Hello Anne-Marie,
Attached is our submission for the above DA for outdoor Pickleball Courts at Pittwater RSL.

Submission – DA2024/0675

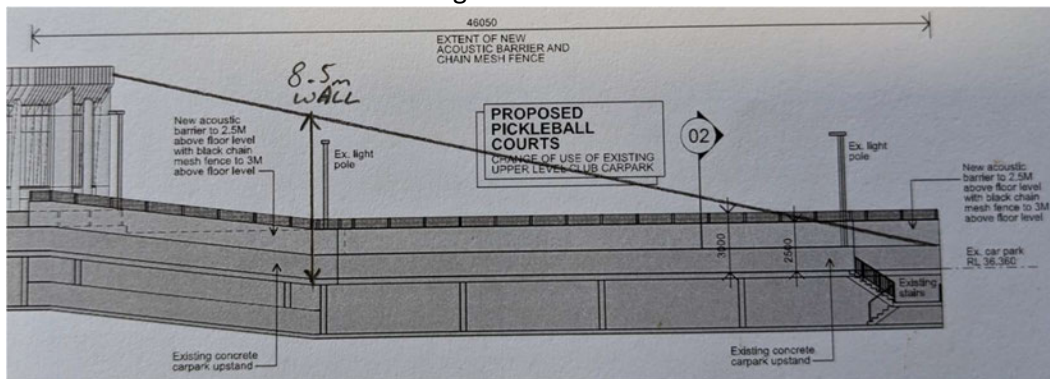
- The impacts are NOT for the most part internalised as the courts are outdoor and allow noise to carry to residential properties.
- The recommended 2.5m high acoustic barrier AROUND the courts will NOT stop REFLECTED noise from the face of the main RSL structure as happens now from music and chatter on “The Deck” adjacent. The submitted drawings also only show this barrier being proposed along the northern side of the carpark. If this reflected noise is to be stopped reaching nearby residences, then an 8.5m wall would be needed at the eastern end of the courts as in the below diagram.
